Nowra Bridge Project

Submissions report

Roads and Maritime Services | May 2019

Figure 4-1: Revised design for the Princes Highway/Illaroo Road intersection

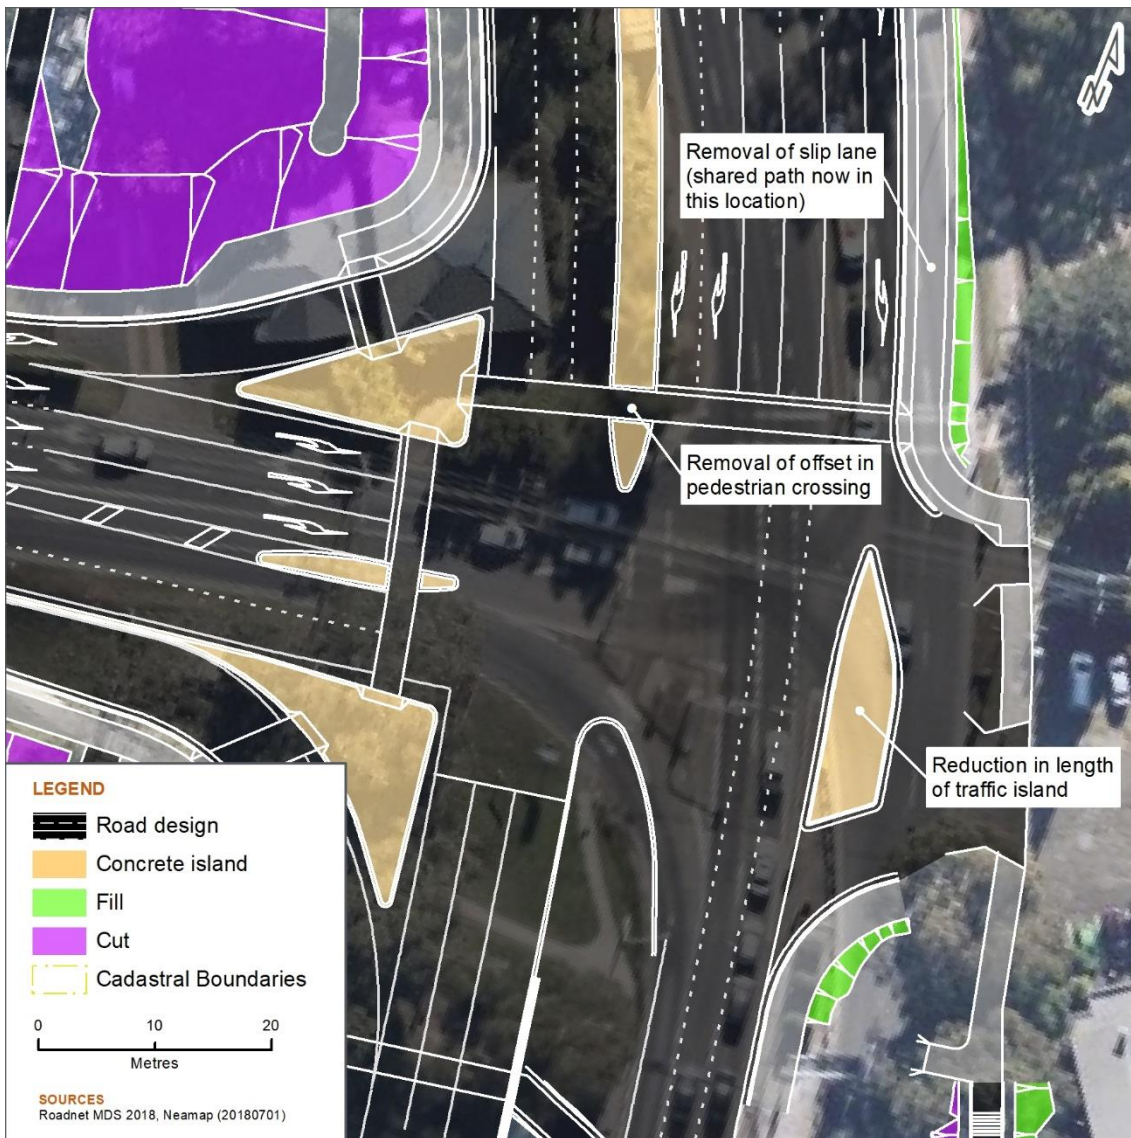
The revised design for the intersection is shown in Figure 4-1.

No additional or revised safeguards and management measures are proposed for the design changes to the Illaroo Road intersection.

Figure 4-2: Revised design for new local road connection

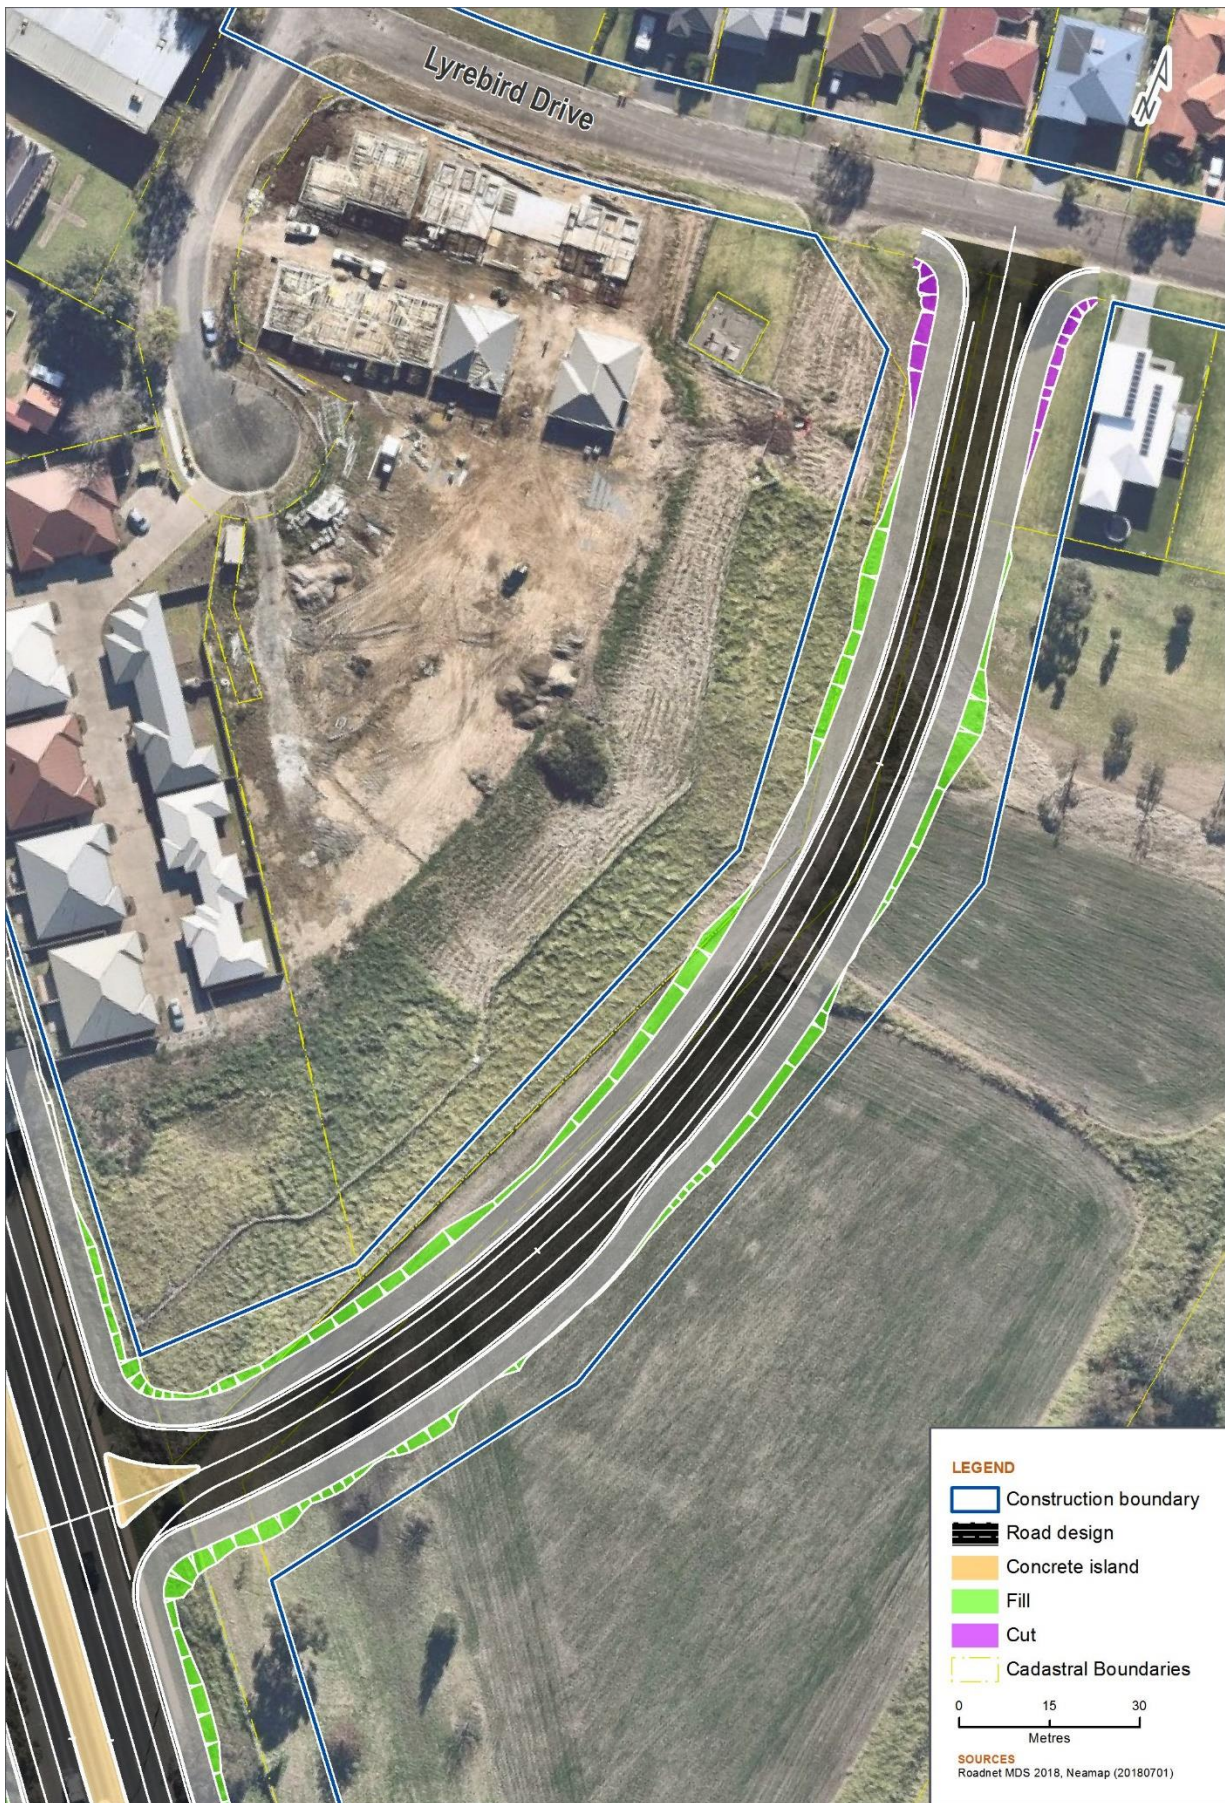
Both of these design changes improve safety for road users. The revised design is shown in Figure 4-2.

Figure 4-4: Potential additional ancillary facility sites

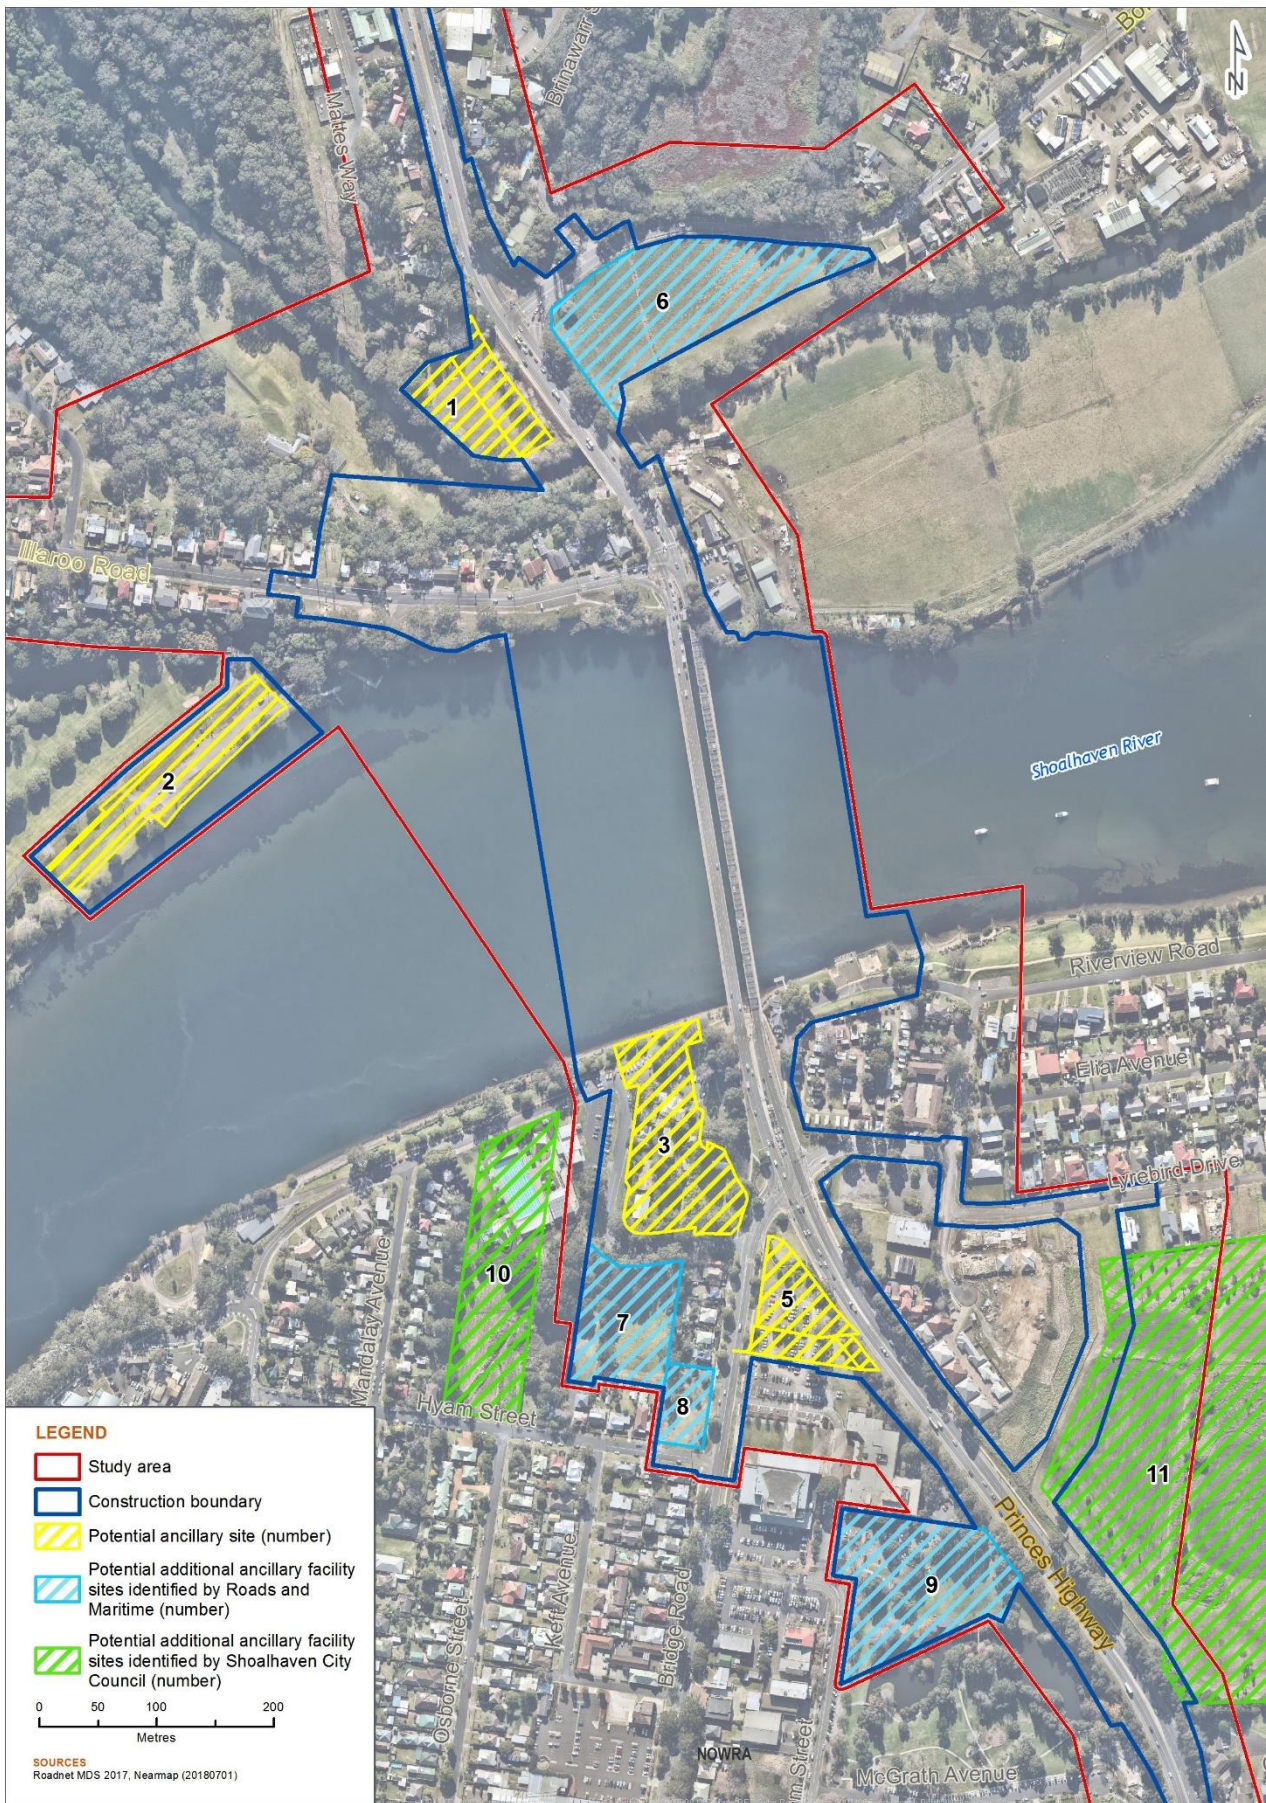
Following the display of the REF, Roads and Maritime Services identified four additional sites for assessment as potential locations for additional construction ancillary facilities. The description and location context for each the proposed additional ancillary facility sites are described in Table 4-1 and the locations are shown in Figure 4-4. A further two additional areas for potential additional ancillary facilities were also proposed by Shoalhaven City Council; these are described in Table 4-2 and their locations also shown in Figure 4-4. The additional potential sites have been numbered to follow on from the proposed sites identified in the REF.

Ancillary site 4 identified in the REF, located on the northern half of the Graham Lodge property, is no longer proposed to be used in view of the heritage values of the property and to avoid impacts to the existing business operating from the former Shoalhaven Visitor Information Centre building.

Figure 5-1: Location of proposed noise barrier

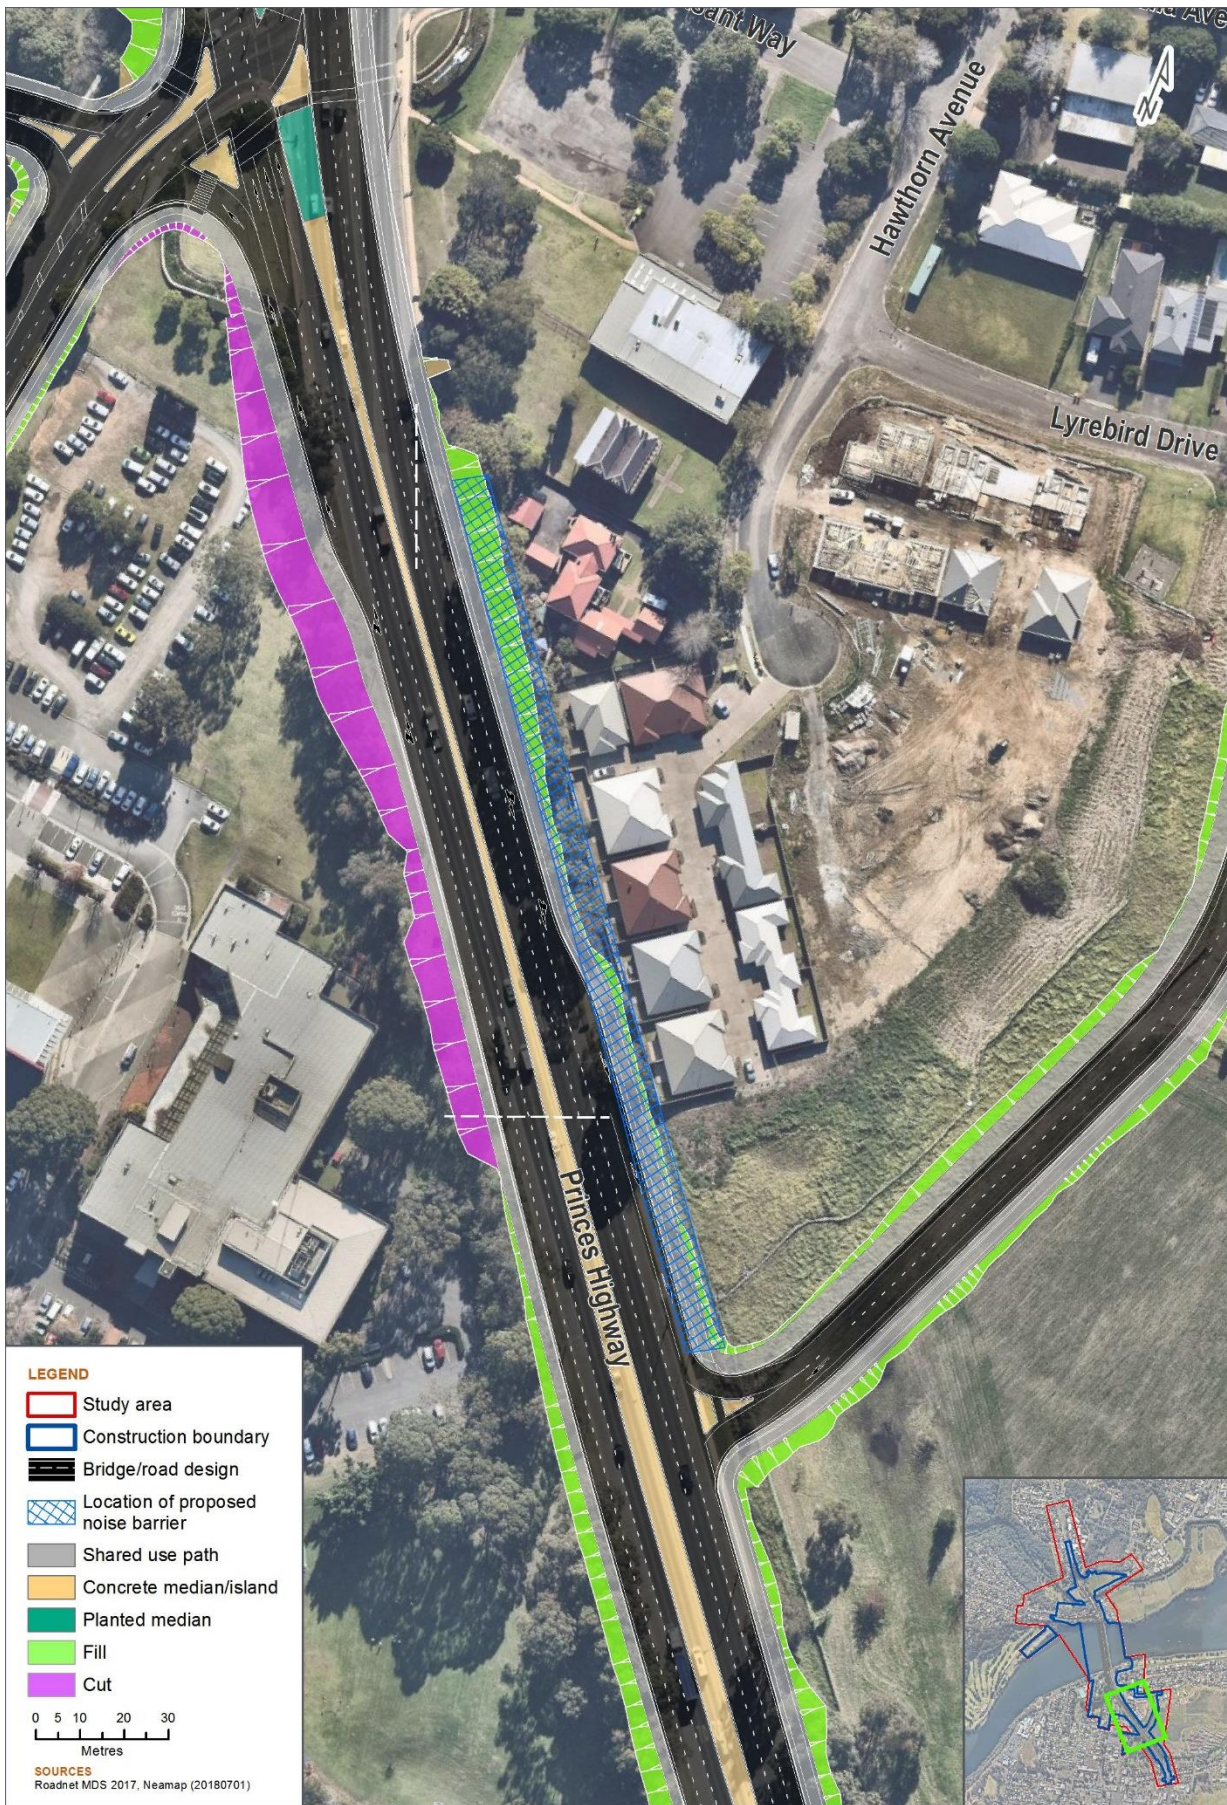
The proposed noise barrier would be located on the eastern side of the highway between the shared path and the adjoining property boundaries (refer Figure 5-1). The width of this area is about 8-10 metres and is within the existing construction boundary. The barrier would extend from the southern boundary of Graham Lodge to the new local road connection, a distance of about 200 metres. There is existing boundary fencing 1.8 metres in height running along the rear of the properties.

The northern end of the proposed noise barrier would be located at the southern end of the property boundary of the State heritage-listed Graham Lodge, outside the heritage curtilage of the property. The barrier would partially obscure views from Graham Lodge to the general south-east for a
